HISTORIC AND DESIGN REVIEW COMMISSION

August 02, 2017

HDRC CASE NO: 2017-378
ADDRESS: 423 MISSION ST
LEGAL DESCRIPTION: NCB 946 BLK 2 LOT 24
ZONING: RM-4,HS
CITY COUNCIL DIST.: 1
DISTRICT: King William Historic District
LANDMARK: House
APPLICANT: Fernando Morales
OWNER: Pamela McClain
TYPE OF WORK: Installation of front gravel driveway
REQUEST:

The applicant is requesting a Certificate of Appropriateness for approval to install a new front yard gravel driveway to be approximately 10-feet wide and 22-feet long. The proposal includes a new concrete curb cut to measure 13'-0" at the base of the apron.

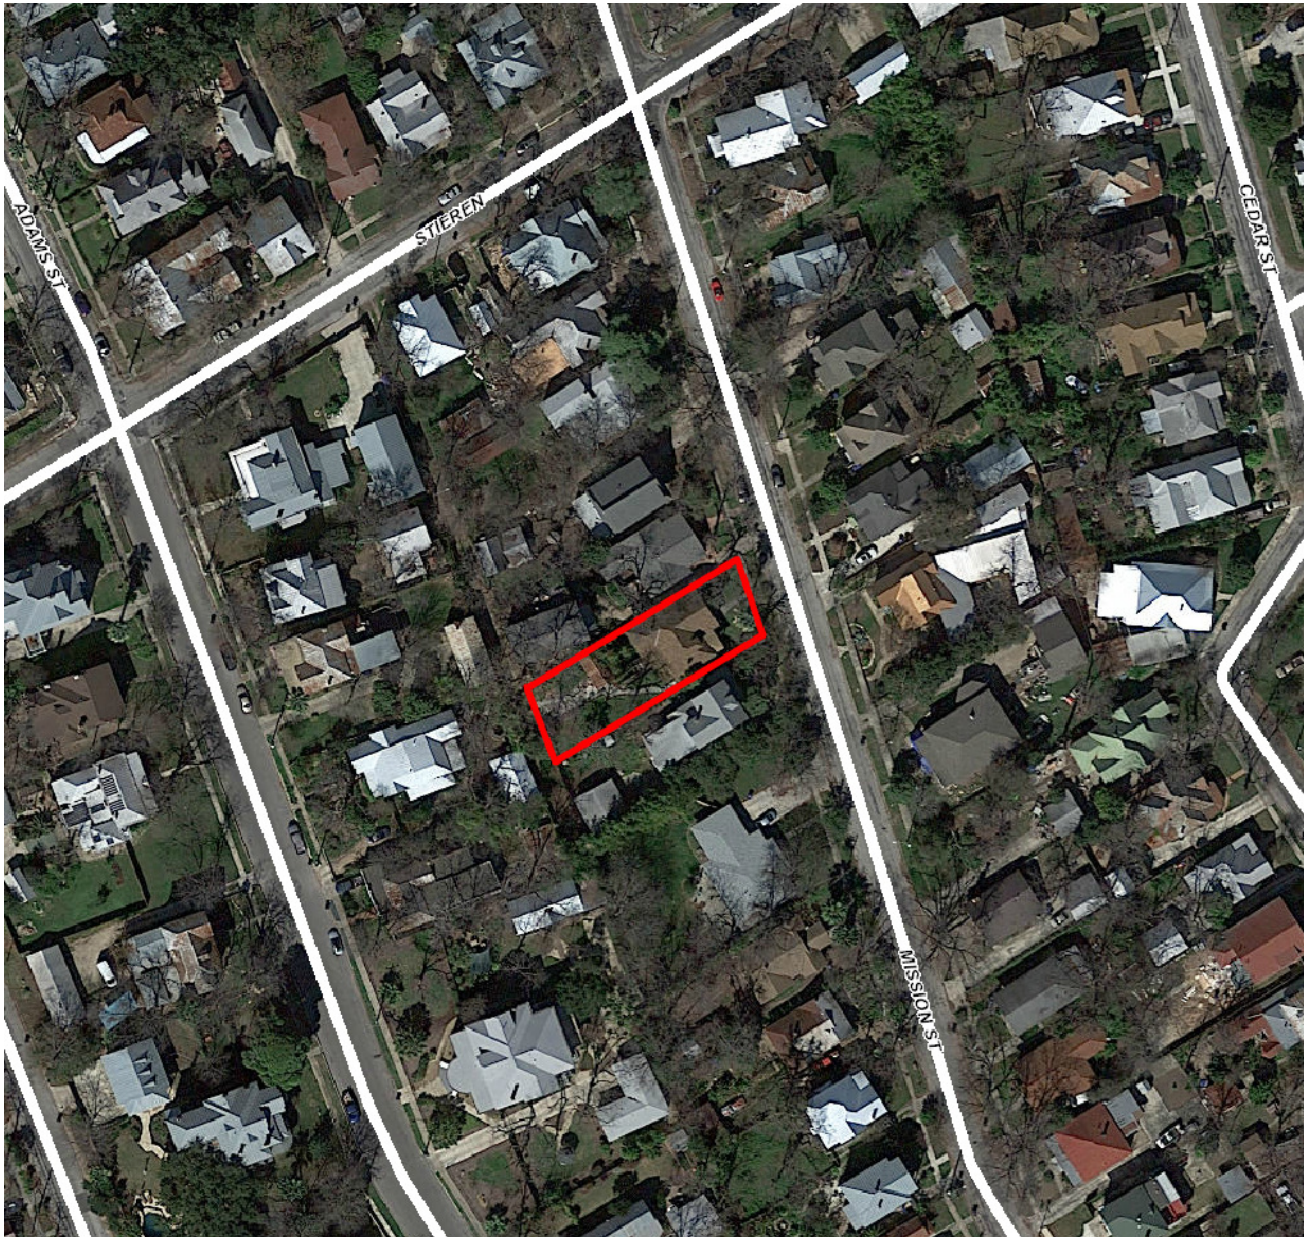
- b. **LOCATION AND CONFIGURATION** – The applicant has proposed to install a gravel driveway on the southwestern edge of the property. The driveway will be confined to the front yard and will not extend the full depth of the lot due to the placement of the primary structure relative to the property's side lot lines. The driveway will measure 10'-0" in width and 22'-0" in length. According to the Historic Design Guidelines, new site elements should work with the existing character-defining topography. Driveways should be limited to 10 feet in width to maintain consistency with historic driveway configurations. The proposed width and location of the driveway is consistent with historic locations on nearby blocks and the within the district, including its confinement to the front yard only and its materiality. Additionally, its placement will not obscure the character-defining elements of the primary historic structure. Staff finds the proposal consistent with the Guidelines based on site and district-specific considerations.

- c. **CURB CUT** – The proposed driveway will also contain a new curb cut. The curb cut will be poured concrete and measure 13'-5" at its widest point adjacent to the street. The apron will taper to the 10'-0" width of the driveway where it meets the existing sidewalk. According to the Historic Design Guidelines, new curb cuts should not be introduced where historically found; however, curb cuts and aprons of the proposed configuration can be found along this block of Mission St. New or replacement curbing should match the historic curbing configuration of the block and district. Staff finds the proposal consistent with the Guidelines.

- d. **EXISTING TREES** – The driveway will be poured between three existing trees on the property. Two are directly adjacent to the side lot line, and a palm tree is located approximately 15 feet from the side lot line. According to Guideline 3.D.i, existing mature and heritage trees should be preserved. The location of the driveway will not require the removal of any of these trees. Staff finds the proposal consistent with the Guidelines.

Staff recommends approval based on findings a through d.
